UNITED STATES PATENT AND TRADEMARK OFFICE

APPLICATION NO.	FILING DATE	FIRST NAMED INVENTOR	ATTORNEY DOCKET NO.	CONFIRMATION NO.
10/820,743	04/09/2004	Wei-Jye Lin	MR2707-61	8811
4586	7590	06/07/2005	EXAMINER	
ROSENBERG, KLEIN & LEE 3458 ELLICOTT CENTER DRIVE-SUITE 101 ELLICOTT CITY, MD 21043			KIM, SU C	
			ART UNIT	PAPER NUMBER
			2823

Office Action Summary

DETAILED ACTION

FIG. 2

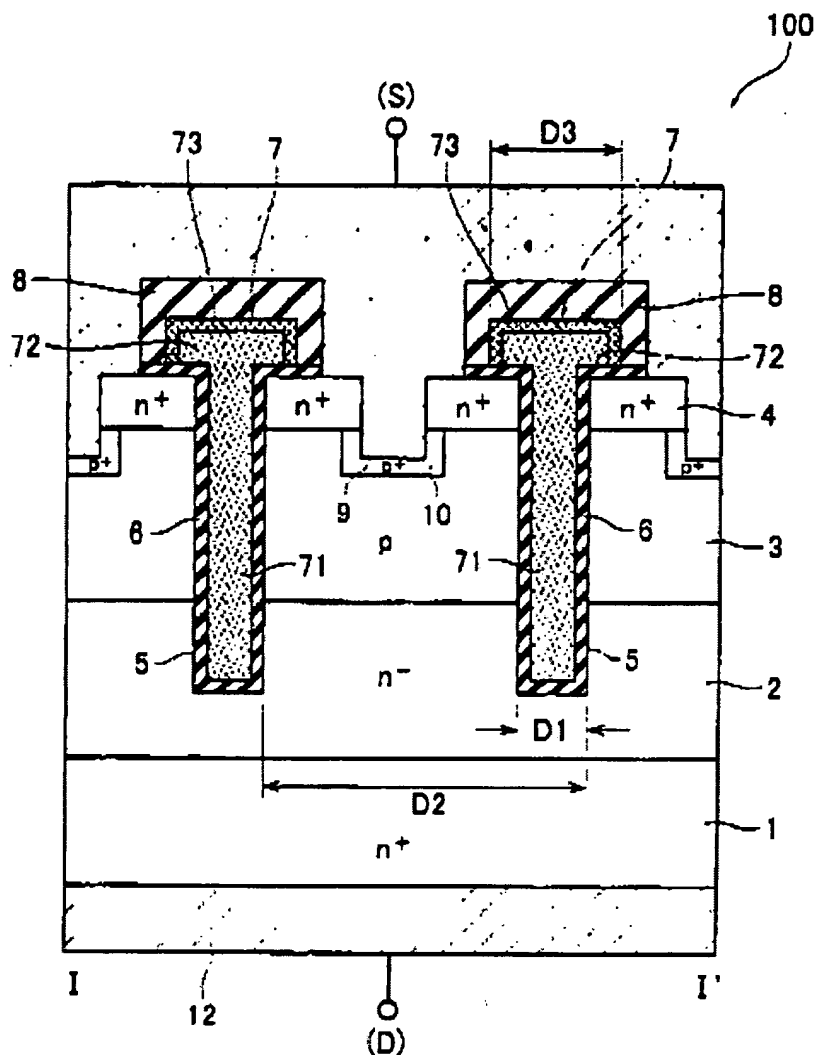
Takano discloses a method of [insert title of reference] as claimed. **See all the FIGS** where Takano teaches the following limitations

filling a metal 11 (**See FIG 1A**) in said contact hole for contacting said sidewall of said first shallow layer and said second shallow layer (**See Fig 2, Please note Takano shows source contact layer (S) on the top of semiconductor layers, which is typically metal conductive layer**).

7. Pertaining to claim 12, Takano discloses the contact process of Claim 1, further comprising a blanket etching to said second shallow layer prior to said filling a metal in said contact hole (**Please see Fig 2. Source (S) and Drain (D) are connected on the top and bottom of semiconductor. To electrically connect Metal oxide semiconductor, the layers on the top and bottom of semiconductor must be metal conductive layer as shown FIG 2**).
